ST. TAMMANY PARISH

Addendum No.: 4

Bid#: 19-01-2

Project Name: Lift Station and Blower Control Electrical Panels

ATTACHMENT "B" - REVISED

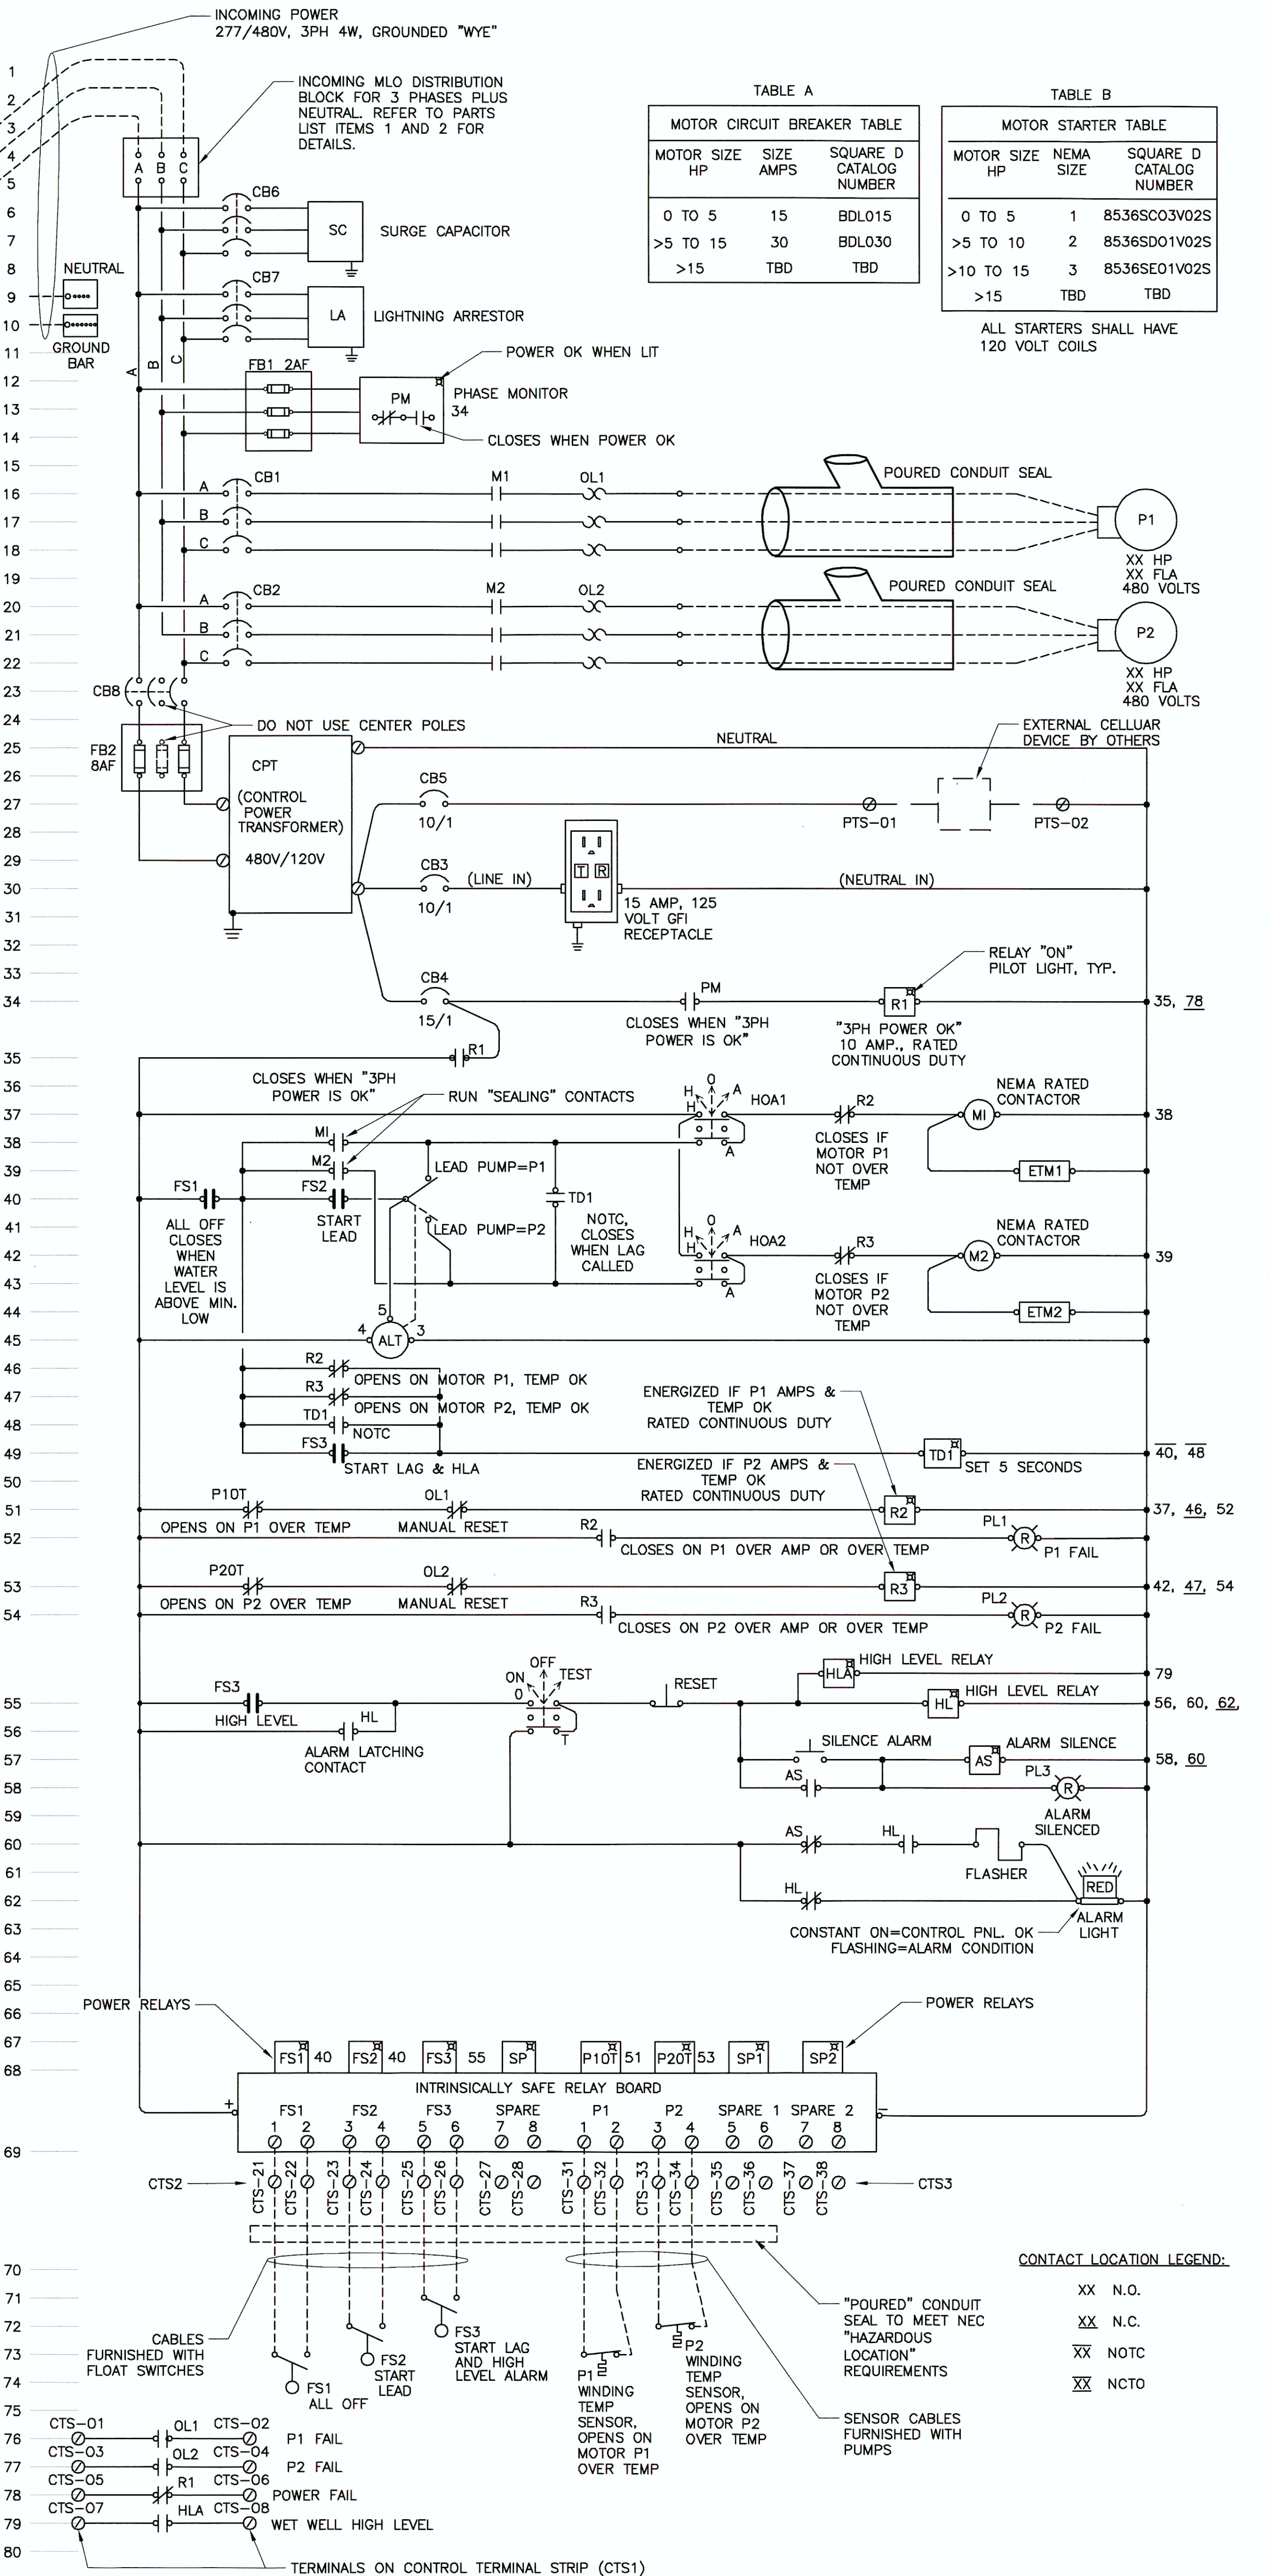
4. Please delete **Attachment "B" 480 Volt Duplex Lift Station Standard Control Panel** and replace with **Attachment "B"-REVISED 480 Volt Duplex Lift Station Standard Control Panel**. Table A and Table B have been modified.

Question #1: I am not sure what to do here. I know this is a technical question, but regarding the note on motor starters. It says to use a Size 3 motor starter on motors greater than 5HP, but less than 15 HP – that is all well and good, but this will not work for the 5 HP unit and 7.5 HP units as there are no overload heaters available for that small of a motor for use w/ such a large motor starter. Minimum amperage on heater for a size 3 starter are 14.3 Amps. The 5HP draws 7.6 FLA and the 7.5 HP will draw somewhere close to 11FLA. We cannot provide proper protection using this size 3 motor starter for 5 and 7.5 HP panels.

Question #2: I understand maybe wanting to oversize these units a little, but Officially they are rated for the HP's as follows.
Size 1 starter is rated for .5 HP to 7.5 HP at 230V and 0 to 10HP at 480V
Size 2 starter is rated for 10 HP at 230V and 15 HP to 25 HP at 480V
Size 3 starter is rated for 20 to 30 HP at 230V and 30HP to 50 HP at 480V
Size 4 starter is rated for 40 HP to 50HP at 230V and 60 HP to 100 HP at 480V

Question #3: Well, small correction, the notes says we can use a size two motor starter on the 5 HP units and it also says to use size 3 for 5 HP units..... conflict for sure. We have to use the size 2 motor starter for the 5 HP and the 7.5 HP there is no way around it

Answer #1: **Table A and Table B for the 480 Volt Duplex Lift Station Standard Control Panel and the 480 Volt Blower Standard Control Panel drawings have been revised (Attached). 5 HP and smaller shall have a size 1 motor starter. Greater than 5 HP up to and including 10 HP shall have a size 2 starter.**

Answer #2: **Table A and Table B for the 480 Volt Duplex Lift Station Standard Control Panel and the 480 Volt Blower Standard Control Panel drawings have been revised (Attached).**

Answer #3: **Table A and Table B for the 480 Volt Duplex Lift Station Standard Control Panel and the 480 Volt Blower Standard Control Panel drawings have been revised (Attached). 5 HP motors and smaller shall have a size 1 motor starter. Greater than 5 HP motors up to and including 10 HP shall have a size 2 starter.**

REVISIONS		
DATE:	REMARKS:	APP'D
2/1/19	MODIFIED TABLE A & B	BDB

ATTACHMENT "C"-REVISED-2

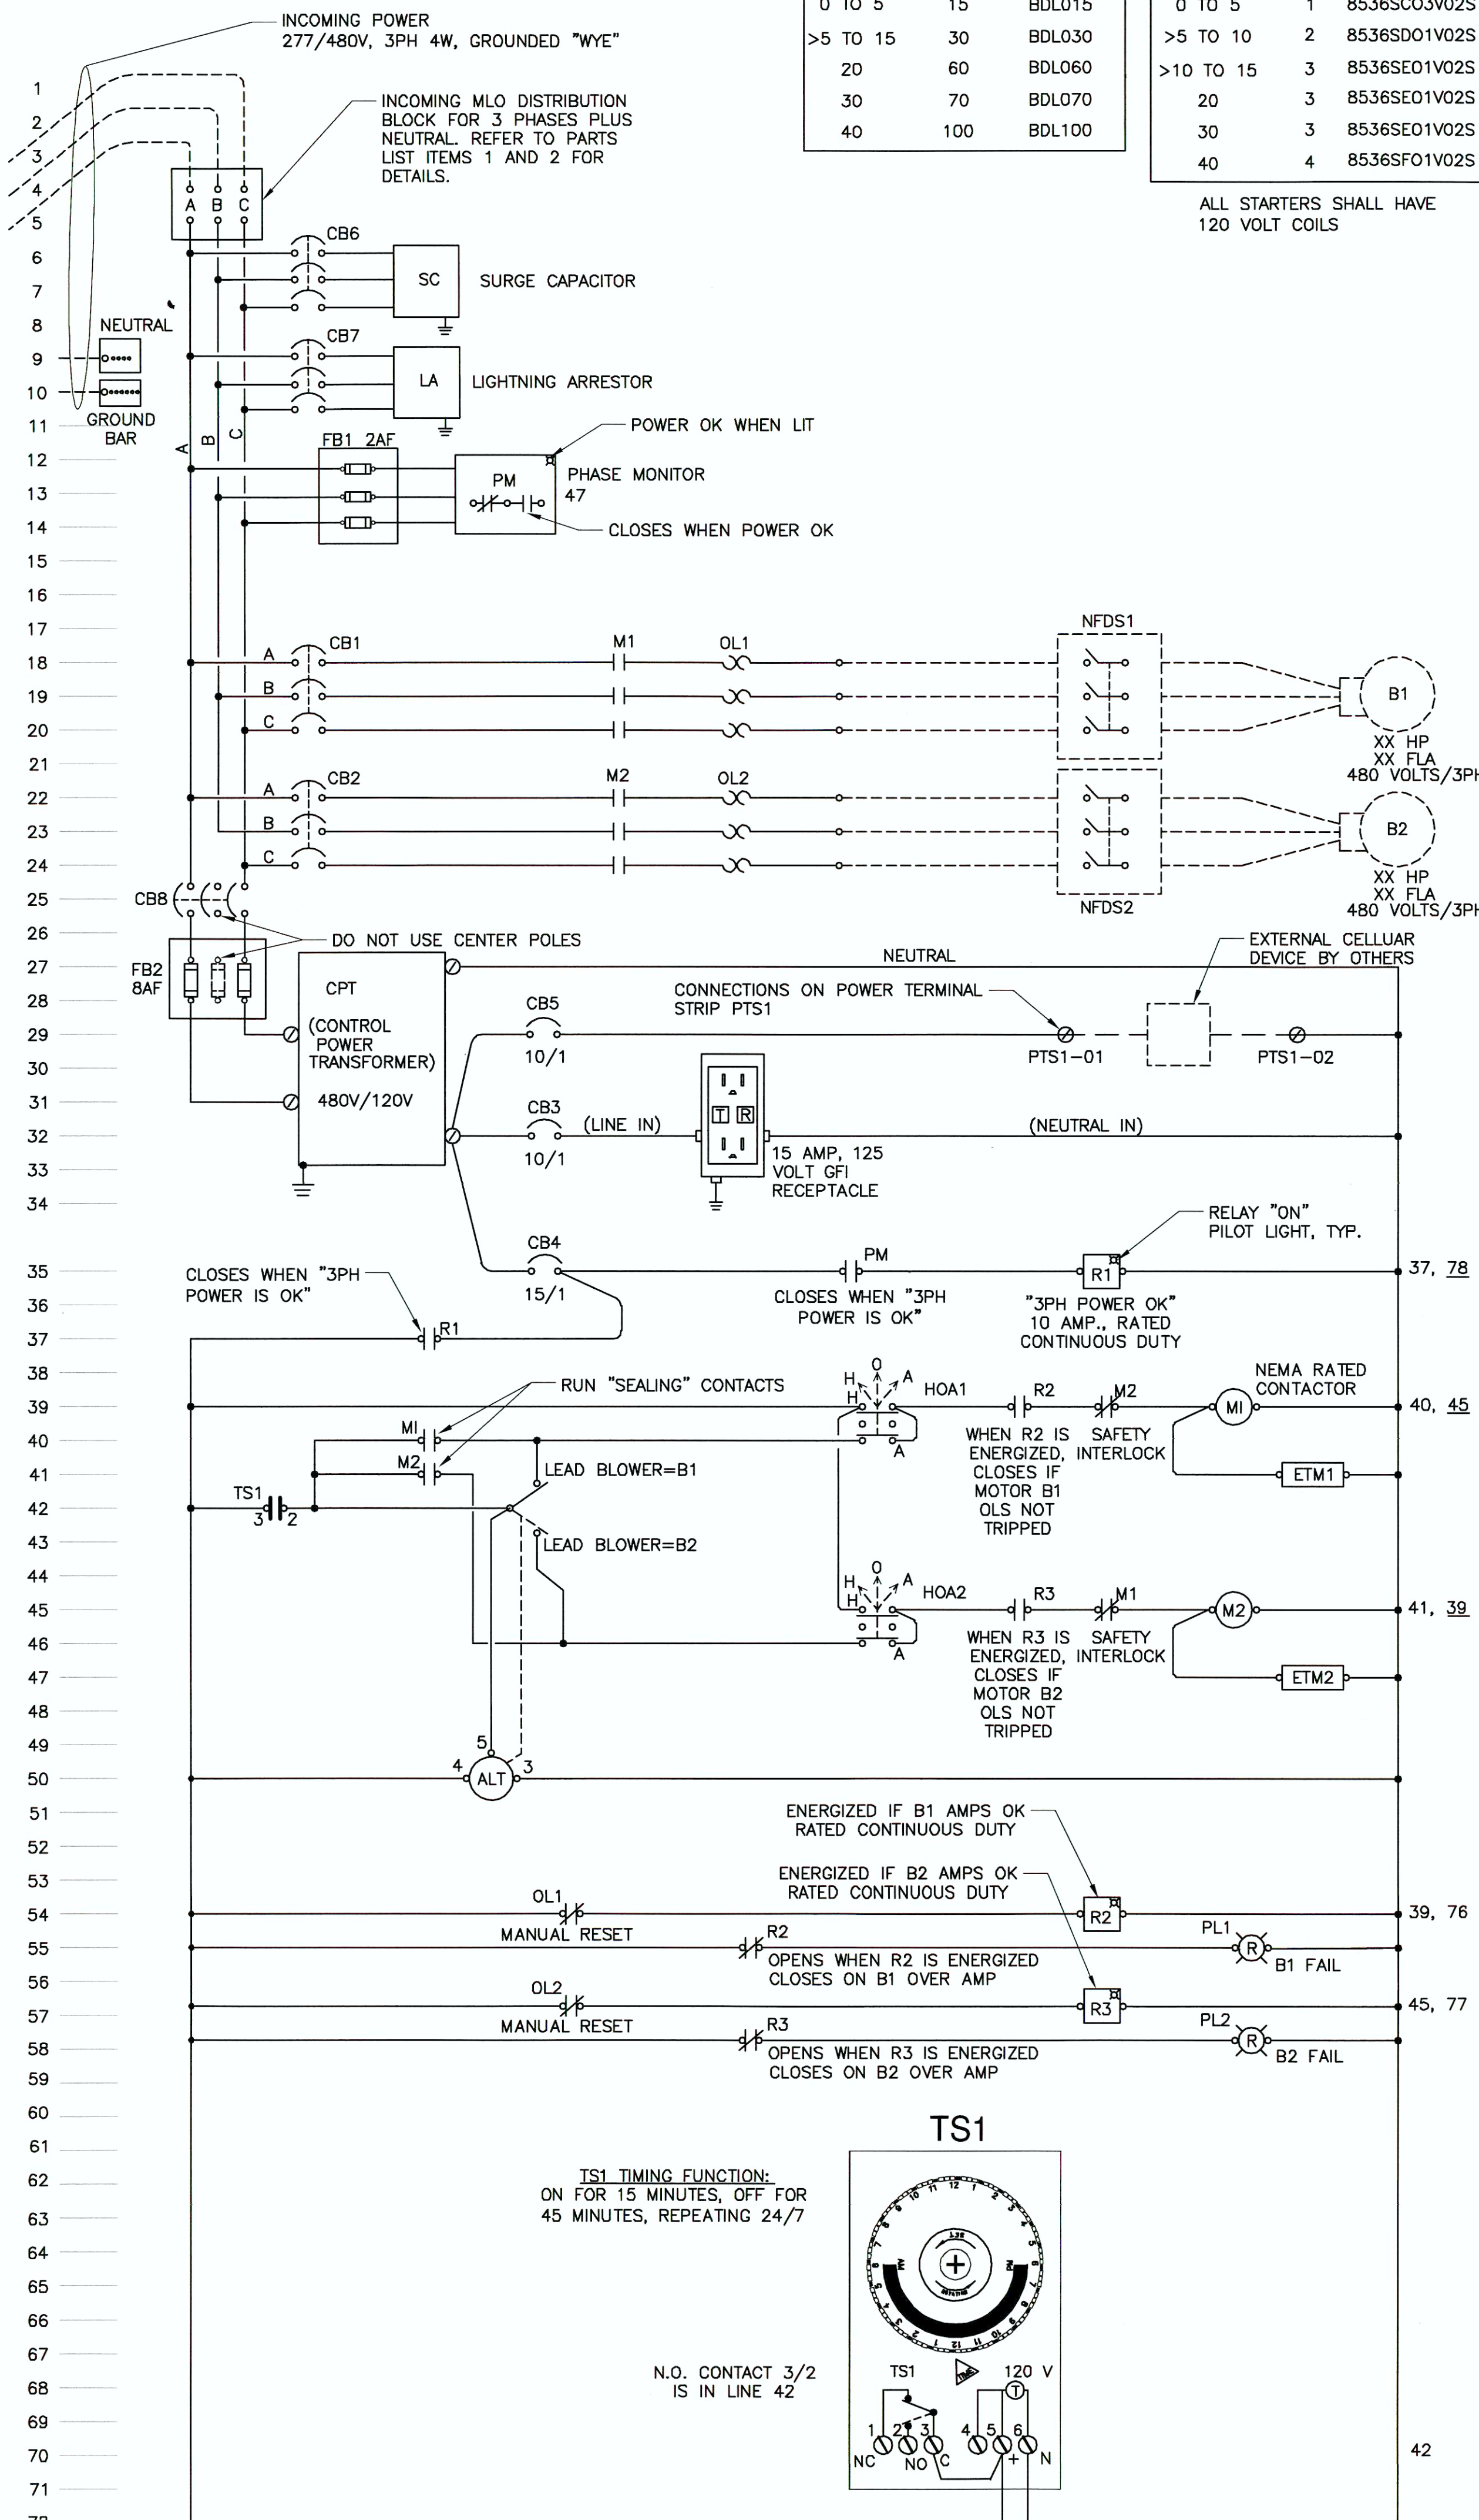
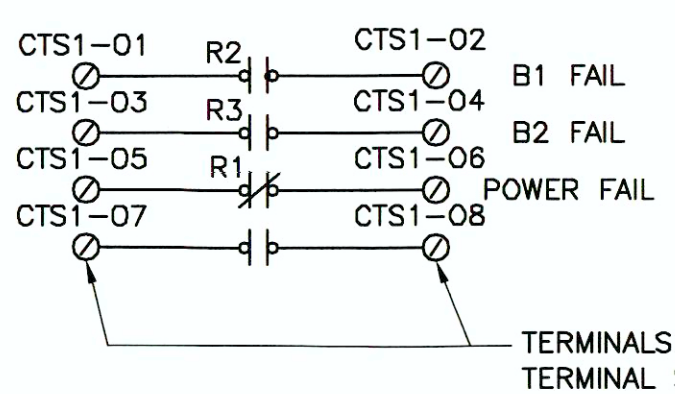
5. Please delete **Attachment "C"-REVISED 480 Volt Blower Standard Control Panel** and replace with **Attachment "C"-REVISED-2 480 Volt Blower Standard Control Panel**. Table A and Table B have been modified.
